#### SECOND AND THIRD READINGS SUMMARY SHEET

CASE: C14-2019-0129 – 10801 Wayne Riddell Loop DISTRICT: 5

#### ZONING CHANGE REVIEW SHEET

10801 Wayne Riddell Loop (District 5) Response to ZAP Recommendation

# 1. Supported Alternative Cross-section for the Wayne Riddell Loop extension

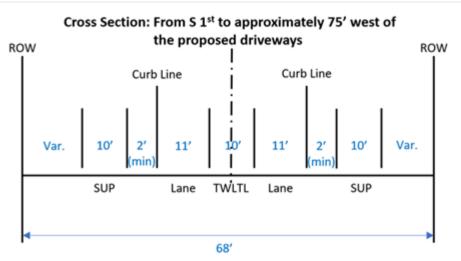
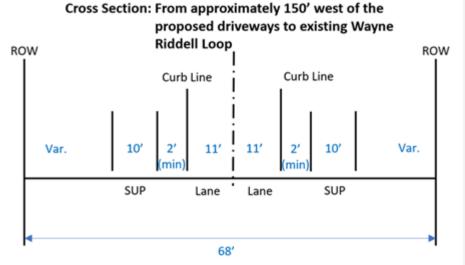
Zoning Case C14-2019-0129 was recommended by Zoning and Platting Commission (ZAP) for approval to City Council on May 19, 2020 with the requirement that prior to the Council consideration staff provide additional assessment of the following alternatives for a revised roadway design of the Wayne Riddell Loop extension:

- Between existing Wayne Riddell Loop and South First Street access, a revised cross section will include an eastbound and westbound 11' travel lane. Both lanes will be surrounded by a 10' pervious shared use path. In total, the cross-section will include these two 10' shared use paths and two 11' travel lanes.
- At South First Street access, cross section will include an additional left turn lane. Cross section will include an 11' travel lane, 11' left turn lane and an 11' travel lane.
- Vehicle speeds on this project's newly dedicated Wayne Riddell Loop right of way are restricted to 20 mph.

Staff supports ZAP's alternative cross-section within the required dedication of 68-ft with the exception that the center turn lane at site's driveways be reduced to 10-ft (from 11-ft) and that a minimum 2-ft buffer be added between the back of curb and the shared-use path. The buffer may be increased to 7-ft for the required planting zone. Exhibit 1 below depicts the recommended cross-section.

Note: If used only as a buffer, the distance from back of curb to SUP must be a minimum of 2'. If used as a tree planting zone, the same area must be a minimum of 7' in width.

Note: (1) If used only as a buffer, the distance from back of curb to SUP must be a minimum of 2'. If used as a tree planting zone, the same area must be a minimum of 7' in width.

(2) A 75' taper is assumed to transition between the two cross section.
